# UNITED STATES PATENT AND TRADEMARK OFFICE

APPLICATION NO.	FILING DATE	FIRST NAMED INVENTOR	ATTORNEY DOCKET NO.	CONFIRMATION NO.
10/614,268	07/07/2003	David H. McFadden	54330/322596	7748
23370	7590	02/04/2008		
JOHN S. PRATT, ESQ KILPATRICK STOCKTON, LLP 1100 PEACHTREE STREET ATLANTA, GA 30309			EXAMINER COCKS, JOSIAH C	
			ART UNIT 3749	PAPER NUMBER
			MAIL DATE 02/04/2008	DELIVERY MODE PAPER

<b>Office Action Summary</b>	Application No. 10/614,268	Applicant(s) MCFADDEN, DAVID H.	
	Examiner Josiah Cocks	Art Unit 3749

**DETAILED ACTION**

**Segment of Fig. 6 of Smith** (the examiner has added the lead arrow and "colliding gas flows" text)

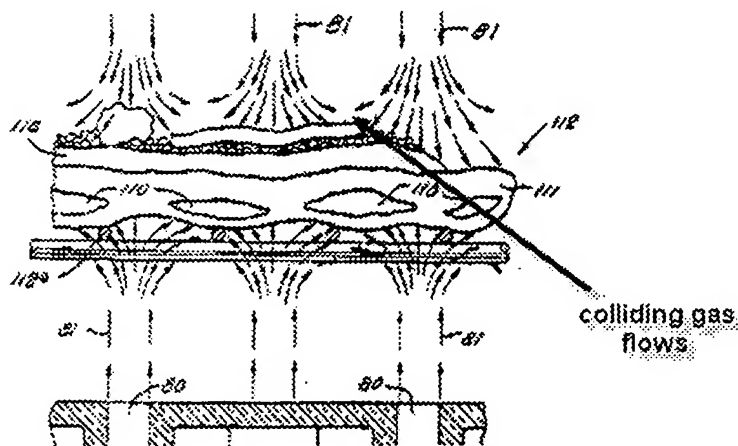
In regard to the recitations that the first and second gas directing means are configured to cause gas from these means to collide upon the upper surface of the food product, these recitations are considered present in Smith. Specifically, in describing Fig. 8, Smith notes that the high velocity jets (81) impinge upon the surface of a food product (P) "to provide very rapid heat transfer and very rapid water vapor removal from the surface of the product." (Smith, col. 10, lines 45-51). Further, Smith also describes that the jets (81) after striking a solid surface are "transformed into a turbulent mushroom shaped pressure area" (see col. 1, lines 6-10). The examiner considers that the above noted descriptions suggest that the gas jets from the gas directing means in either Fig. 6 (unshown tubes 90) or Fig. 8 (upper tubes 126) noted above collide with one another as described. The following are segments of Fig. 6 and Fig. 8 to further illustrate what the examiner considers to be the colliding flows.
